Re: Proposed Revision to the State Implementation Plan for PM2.5 for Allegheny County – Liberty-Clairton Area Attainment Plan

## **Executive Summary for Comments of Citizens for Pennsylvania's Future and The Group Against Smog and Pollution on the Proposed Attainment Demonstration for the Liberty-Clairton PM2.5 Nonattainment Area**

**COMMENTS OF CITIZENS FOR PENNSYLVANIA'S FUTURE AND THE  
GROUP AGAINST SMOG AND POLLUTION ON THE PROPOSED  
ATTAINMENT DEMONSTRATION FOR THE LIBERTY-CLAIRTON PM2.5  
NONATTAINMENT AREA**

**Figure 1: Occupied Homes in Areas Modeled to Exceed the 15  $\mu\text{g}/\text{m}^3$  Annual Standard**

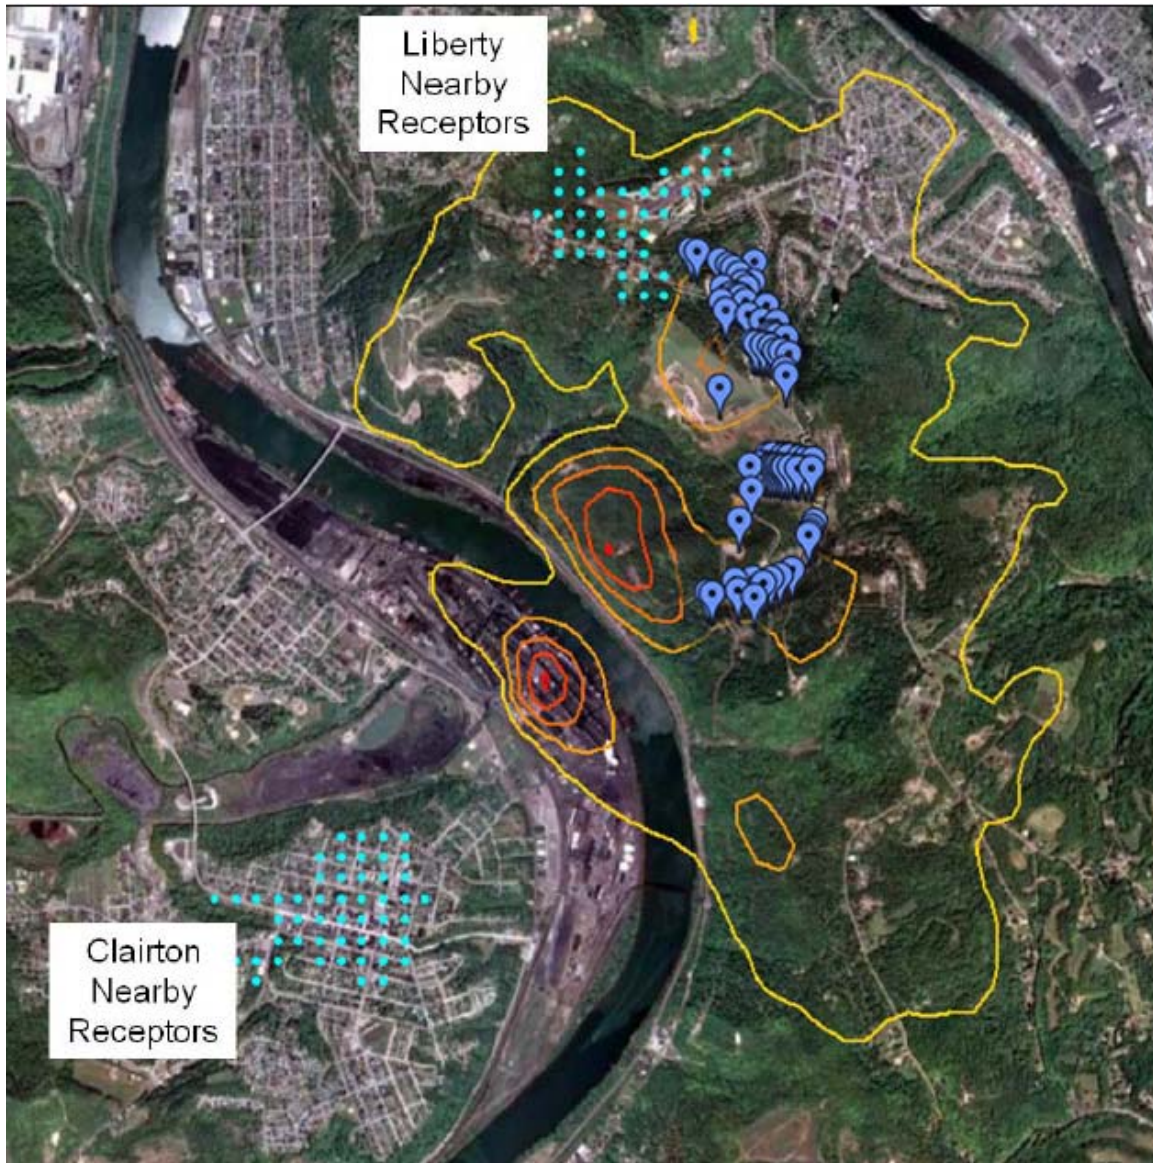
The SIP attempts to justify this omission by arguing that the health and welfare of the residents in this high pollution zone may be sacrificed because “the Lincoln hillside is not suitable as a neighborhood-scale location for analyzing PM<sub>2.5</sub> because it does not represent a populated area.”<sup>7</sup> To test this assertion, GASP surveyed the area expected to be affected (within red and orange lines marked on Figure 8-1), and found 80 occupied homes.<sup>8</sup> The residents of this neighborhood must not be consigned to lifelong exposure to pollutant levels that are known to be deadly.

The SIP also suggests that the regional scale modeling is not suited for comparing resulting concentrations directly with the NAAQS. The SIP explains that these models are used only to determine the relative change in emissions needed to estimate the amount of emission reduction needed to provide for attainment at monitored locations. The regional scale models used (CALPUFF and CMAQ) generate estimates of pollutant concentrations at 500-meter intervals within the area considered to be represented by the Liberty Borough monitor.

But it is precisely because the regional scale models are blunt instruments that are not suited to predicting concentrations on the neighborhood scale near the plant where

pollutant levels will be highest that EPA warned “that nonattainment areas with potential hotspot issues (relatively high concentrations and/or gradients of primary PM2.5) should not rely exclusively on regional modeling.”<sup>9</sup> Instead, EPA “describe[d] an ‘unmonitored area analysis’ which uses interpolated ambient data combined with gridded model outputs to examine whether potential violations of the NAAQS may occur in unmonitored areas. If potential violations are indicated, we recommend further analysis of the problem through additional local modeling. Options for State action to address such a situation could include imposition of reasonably available control technology to reduce emissions, or the deployment of an air quality monitor to further characterize the problem.”<sup>10</sup> ACHD has not chosen either option recommended by EPA. Instead, the draft SIP would sacrifice human health to avoid imposing additional control measures on the Clairton Works. Not requiring the emission reductions needed for attainment wherever the public has access violates the Clean Air Act.
